Project	IEEE 802.16 Broadband Wireless Access Working Group < http://ieee802.org/16 >
Title	Proposed text and ASN.1 code to support MOB_PAG-ADV
Date Submitted	2007-03-13
Source(s)	Joey Chou Intel Corporation [mailto:joey.chou@intel.com]
Re:	
Abstract	This contribution proposes the text and ASN.1 code in wmanIf2mMib to support MOB_PAG-ADV message.
Purpose	Adoption
Notice	This document has been prepared to assist IEEE 802.16. It is offered as a basis for discussion and is not binding on the contributing individual(s) or organization(s). The material in this document is subject to change in form and content after further study. The contributor(s) reserve(s) the right to add, amend or withdraw material contained herein.
Release	The contributor grants a free, irrevocable license to the IEEE to incorporate material contained in this contribution, and any modifications thereof, in the creation of an IEEE Standards publication; to copyright in the IEEE's name any IEEE Standards publication even though it may include portions of this contribution; and at the IEEE's sole discretion to permit others to reproduce in whole or in part the resulting IEEE Standards publication. The contributor als

Figure 19—wmanlf2mBsCm structure

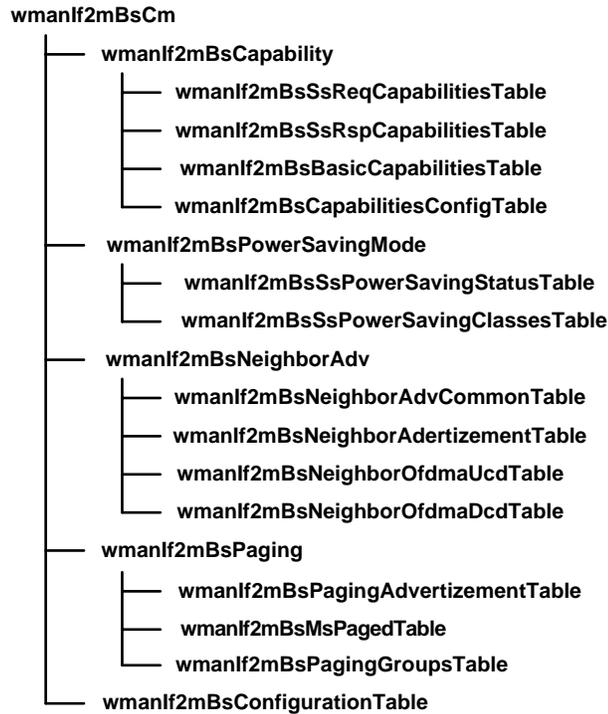
[Change Figure 19 as the following:]
